Staff Report

Re: PLNPCM2019-00953, PLNSUB2019-00954/00955, Axioms Townhomes Design Review, Planned Development and Preliminary Subdivision

Design Review, Planned Development, & Subdivision

PROPERTY ADDRESS: 905, 911, & 915 W Euclid Ave (approximate)

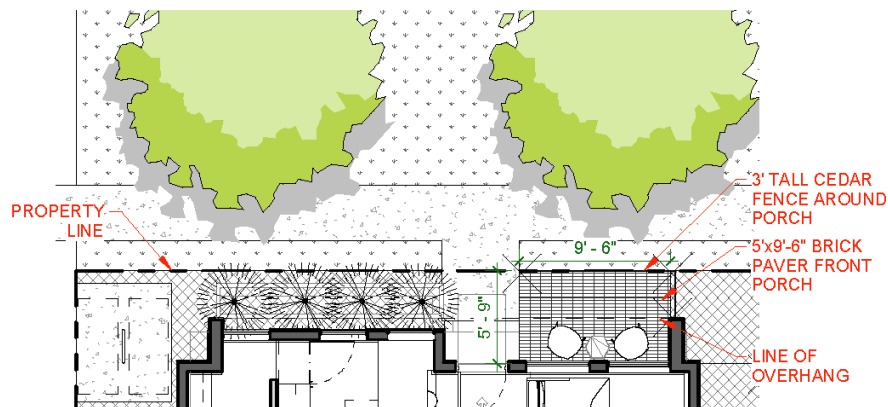
The applicant is seeking modifications to two design standards through the Design Review process. Modifications may be approved if the modification still meets the intent of the specific design standard. The first modification is related to the TSA regulations on stucco or EIFS (“synthetic stucco”). The intent of this standard was to significantly reduce the amount of stucco that developers were using on new development, especially large buildings, where a small percentage allowance on a large building can mean large uninteresting areas of flat stucco. In this case, the developer is using stucco primarily on an architectural feature that creates visual

interest, and it provides a visually interesting texture contrast to the brick and fiber-cement boards used elsewhere on the façade. The incorporation of this stucco feature puts the applicant over the percentage limits for stucco in the TSA zone. However, as discussed, the intent of the stucco limitations wasn't to prohibit small, limited architectural features that would provide greater visual interest. Additionally, the applicant exceeds the overall minimum durable material requirements, providing ~95% durable material on the ground floor (vs. min. 90% requirement) and ~80% durable on the upper floors (vs. min. 60% requirement.) Staff recommends approval of the limited stucco allowance as it provides additional visual interest to the façade, still meets the general intent of the design standard to keep stucco usage at a low level, and exceeds the other minimum durable material requirements.

1 TSA SITE PLAN
1" = 10'-0"

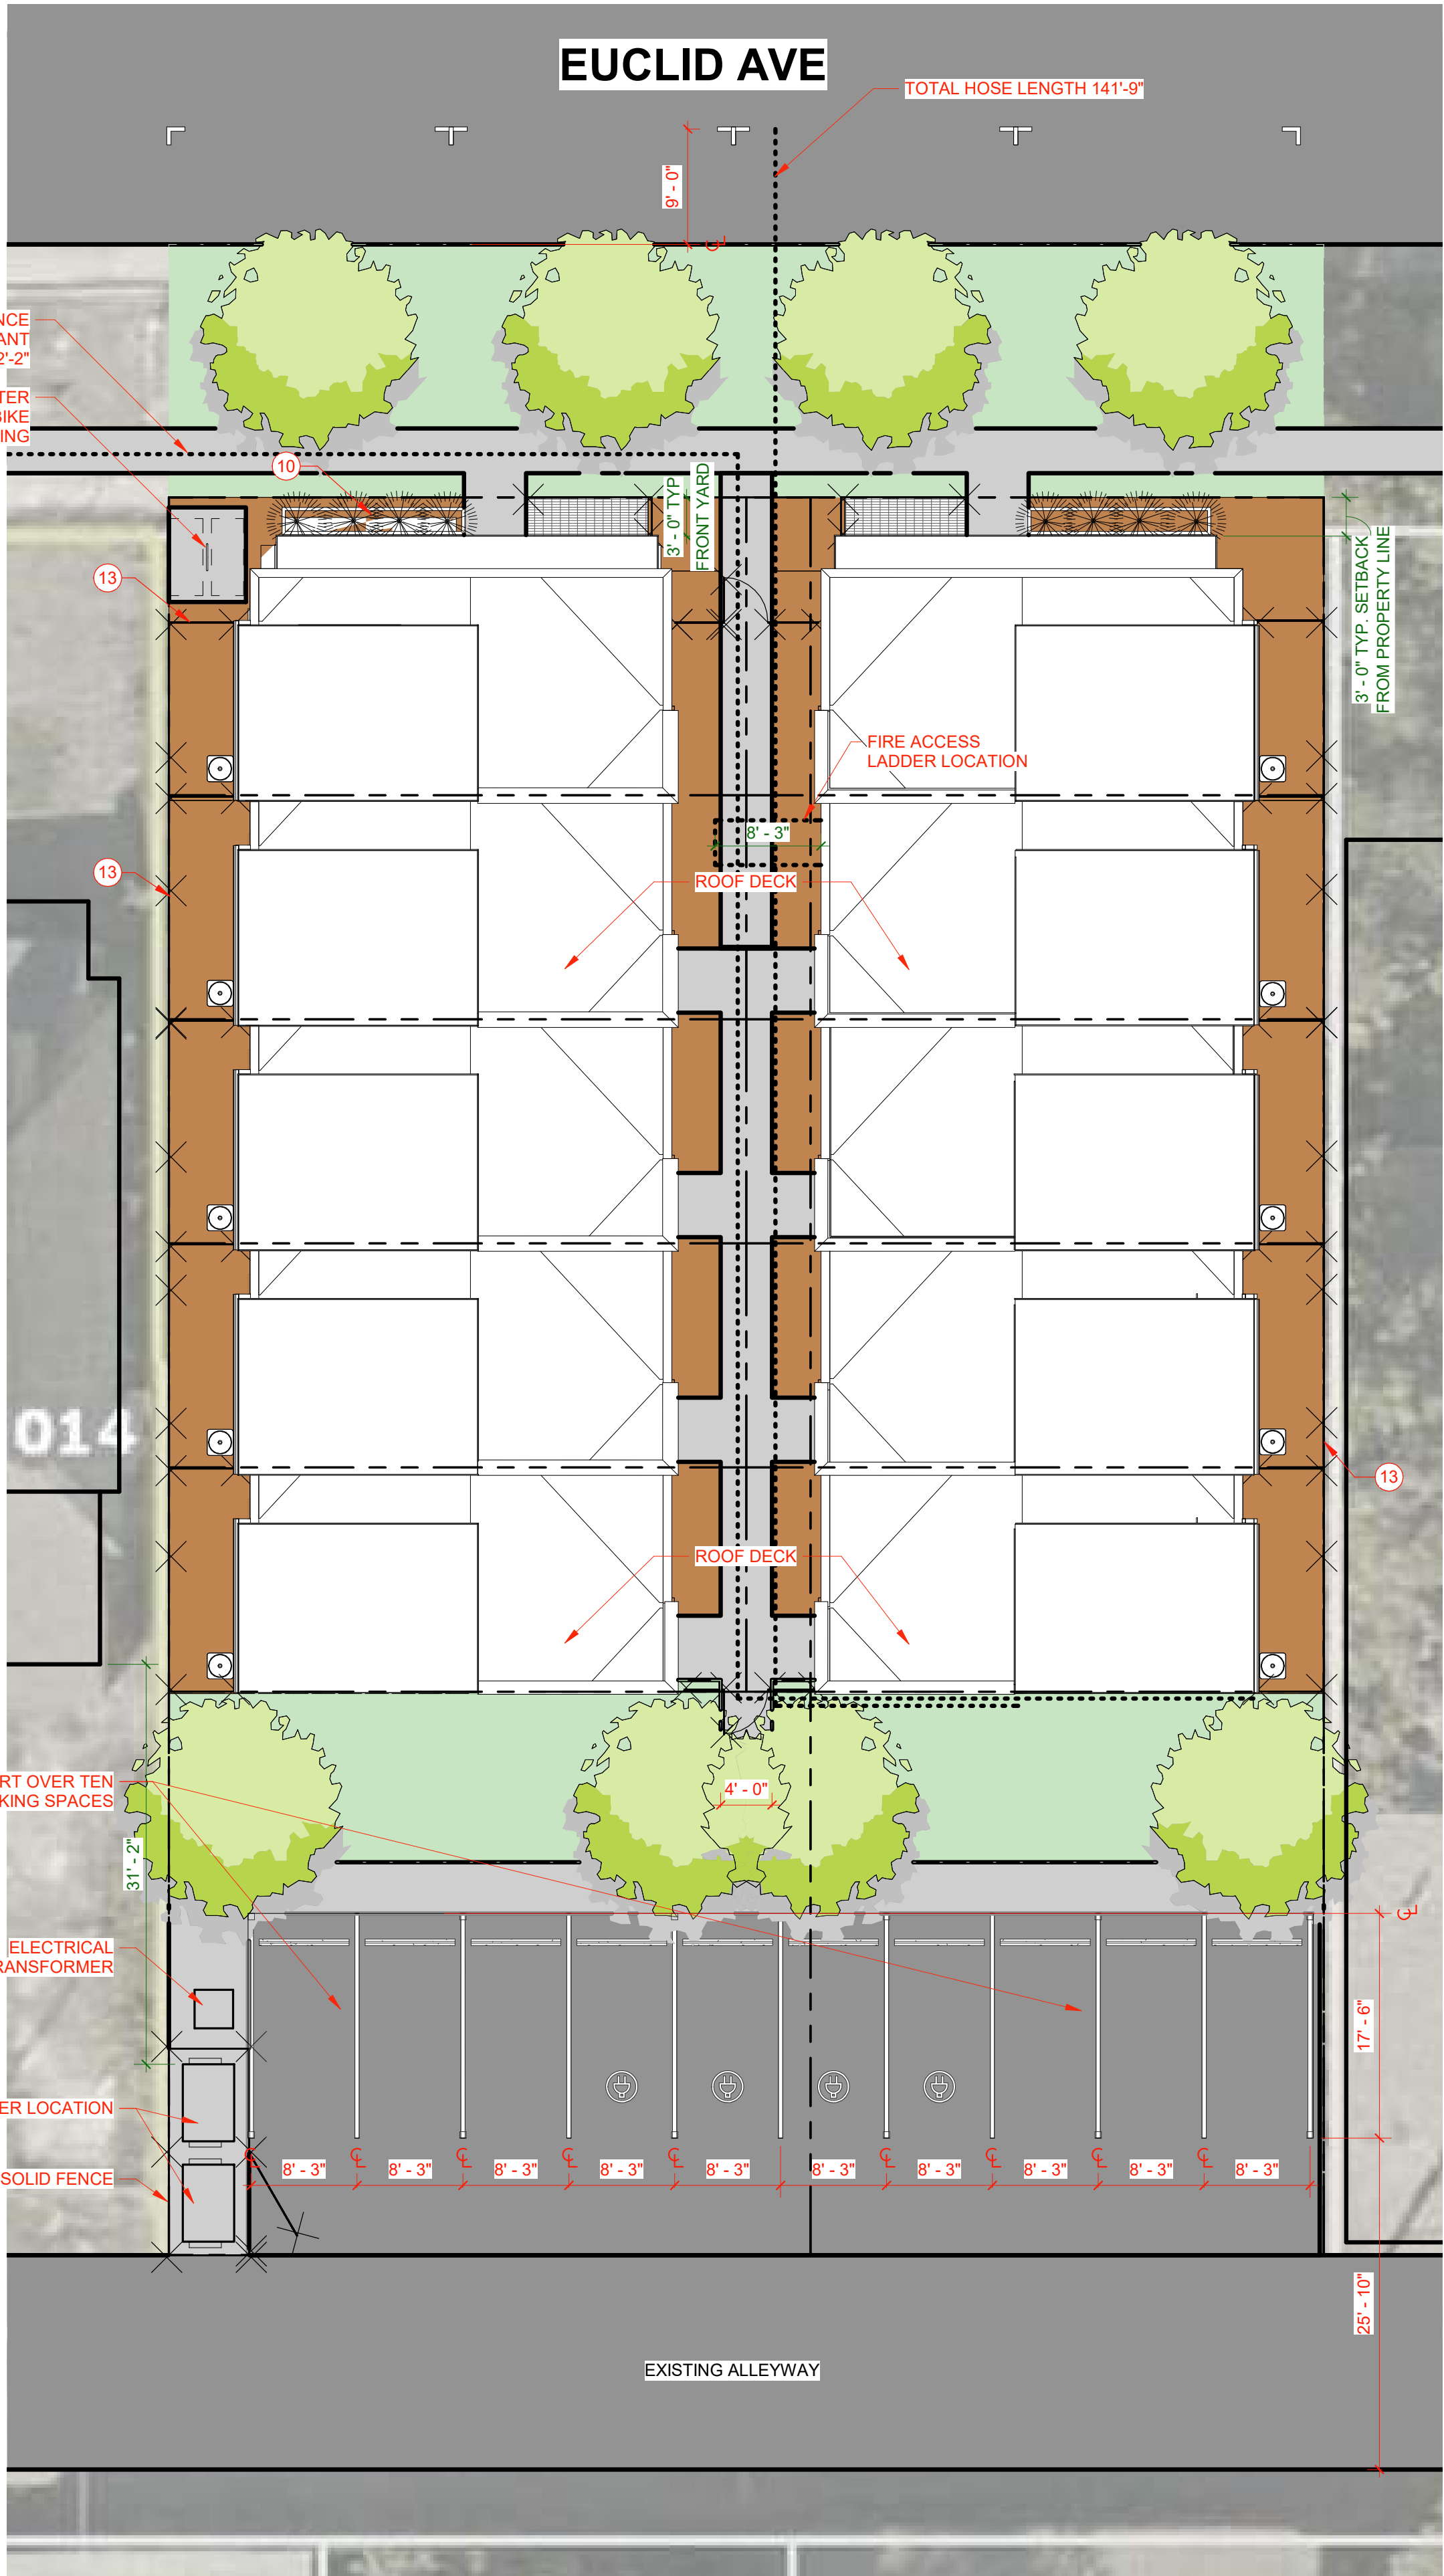
Planning Department		
1	<p>It appears that the building is within 5' of the front property line (as required) due to the overhang feature on the front façade. Please verify this information on the plans to verify setback compliance. (21A.26.078E3b). Requirements can be modified by Design Review if requested.</p> <p>Response: Yes, All of the front facade is within 5' of the front property line. Dimensions have been added to TSA1</p>	TSA1
2	<p>An entry feature is required as per 21A.26.078.F.c. There are four options. It appears that the Euclid facing entrances don't fully meet the dimensional standards of one of the options. It appears from the plans that the entry features are recessed approximately 2.8' from the façade, rather than the minimum 5 feet. A modification can be requested through the Design Review process. You would need to demonstrate that your alternative design meets the intent of the standard as per 21A.37.040</p> <p>Response: Our Entry feature is recessed into the building providing a 2'-8" covered porch. In addition we are providing a brick paver area at that entry to further highlight the front porch area along the sidewalk.</p>	TSA1, TSA2, & TSA3

5 Front Porch Plan
1/8" = 1'-0"

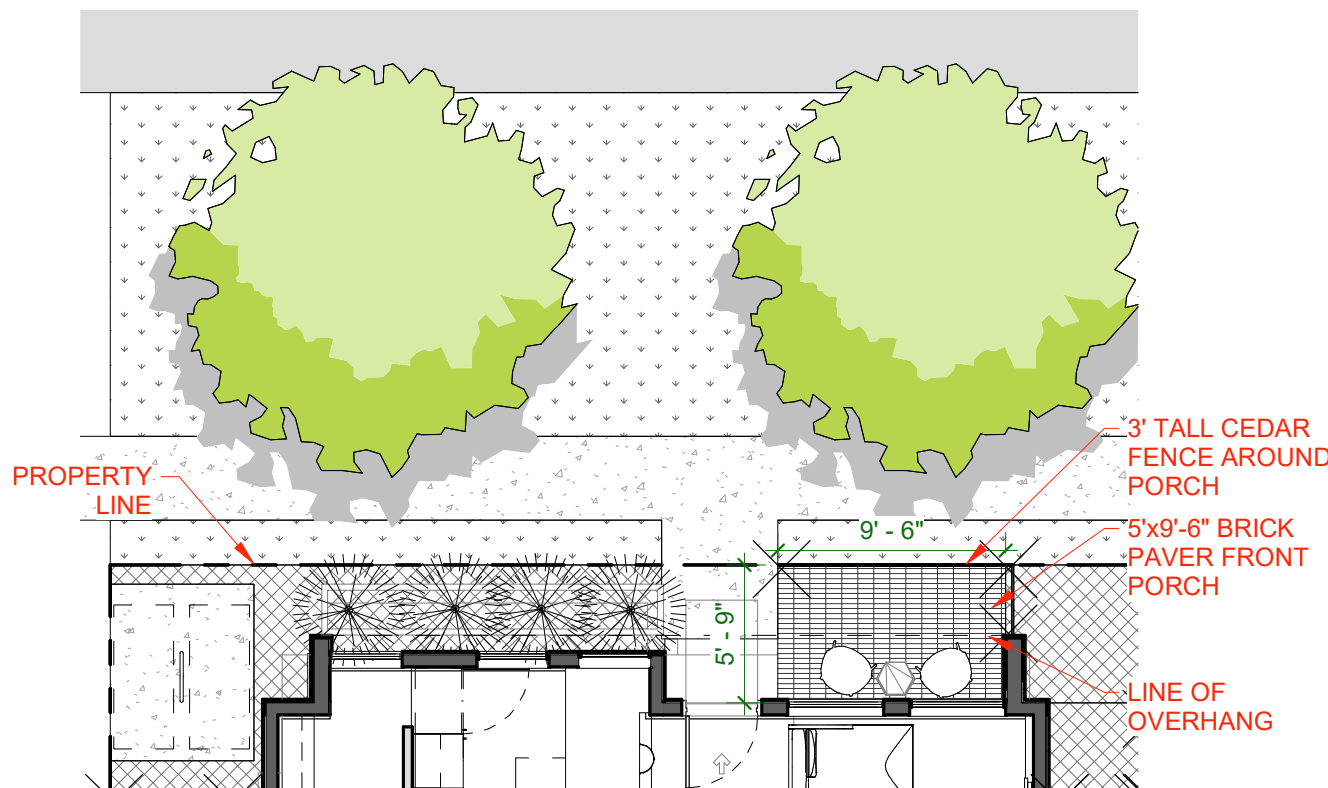
The applicant is also seeking a modification to the entry features required by the TSA zone. Each building is required to have an entry feature and the TSA zone includes four different entry feature options with specific dimensional requirements, these include a 5' deep canopy/awning, a 5' deep recessed entrance, a covered porch at least 5' in depth and 40 square feet in size, or a stoop that is at least 2' above the sidewalk and includes a 3' awning/canopy. The intent of these was to ensure that each building has a significant entrance feature that provides visual and architectural interest and engagement with the street.

Porch site plan showing layout, fence location, and the overhang line (covered portion of the porch/entry area). Applicant is providing ~55 square foot porch (exceeds min. 40 sq. ft for porch) with 5'9" total depth (exceeds 5' min. depth), but with covered depth of ~3' (less than min. 5' covering requirement). No fence/wall is required, but a fence is being included.

2 LANDSCAPE PLAN
1" = 10'-0"

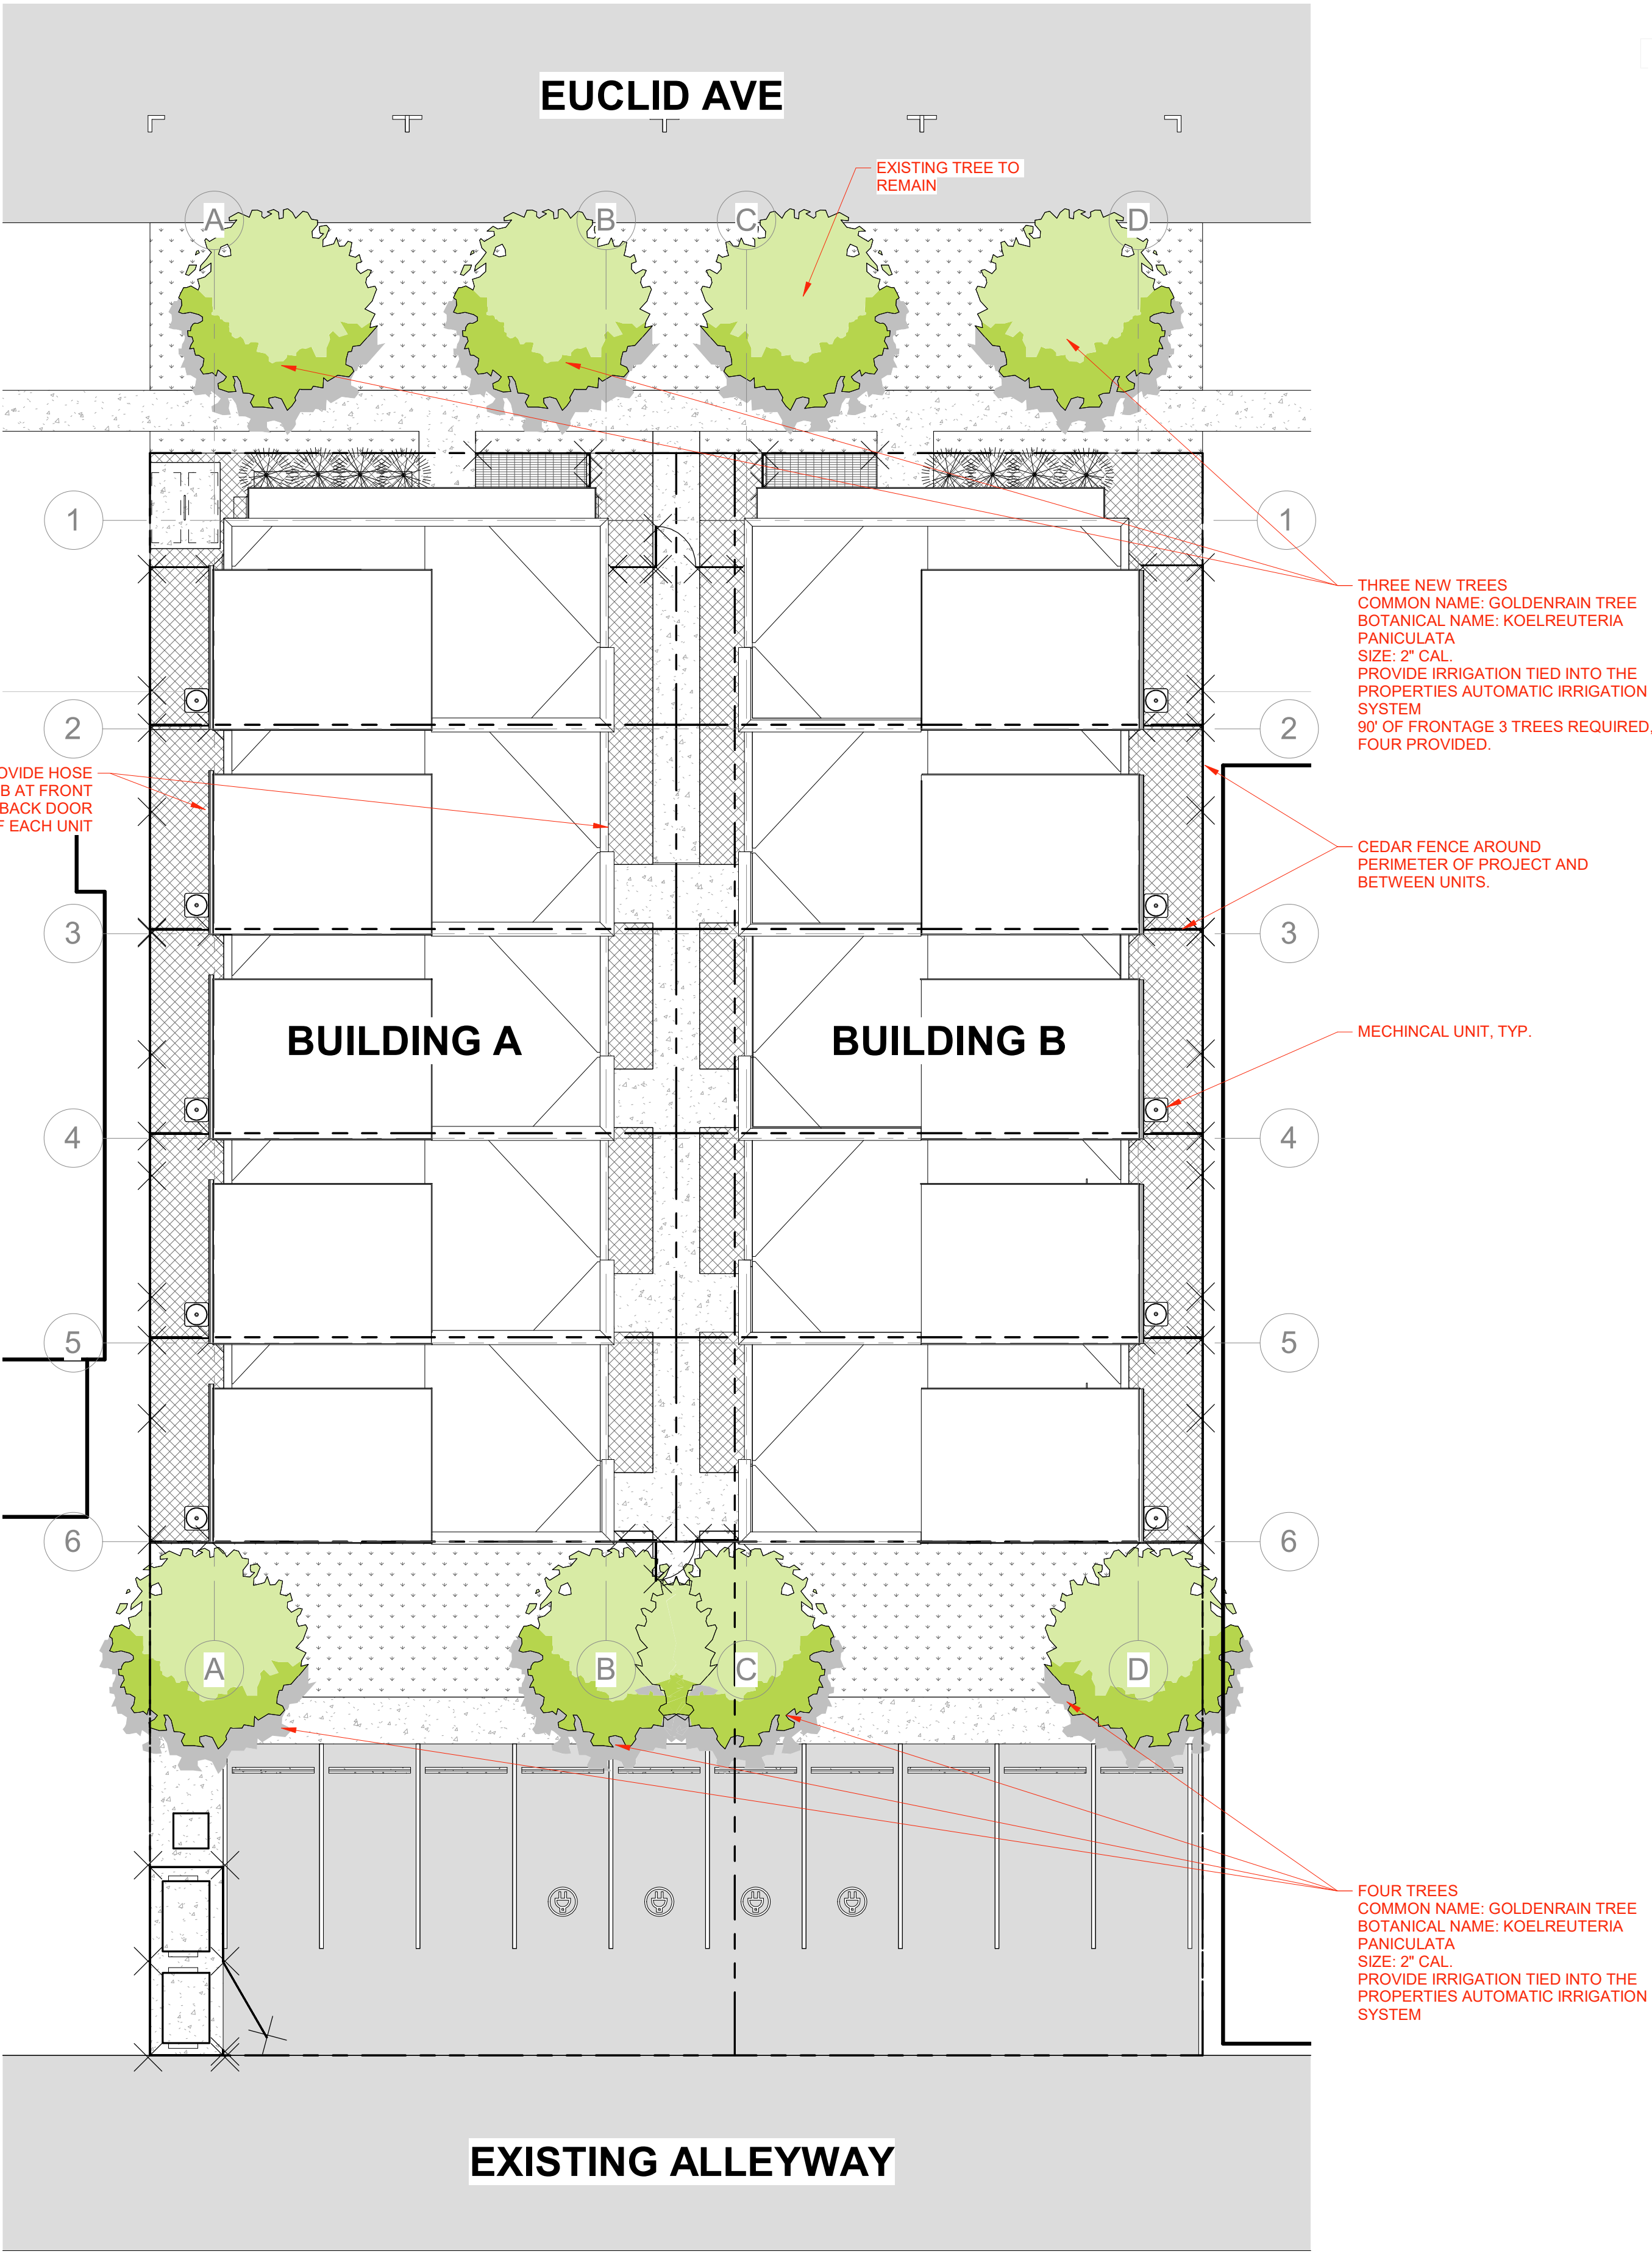
Urban Forestry		
1	<p>Please see the attachments regarding plan review. The submitted drawings don't address the existing trees, or proposed trees with any detail.</p> <p>Response: See the newly included landscape plan.</p>	TSA4
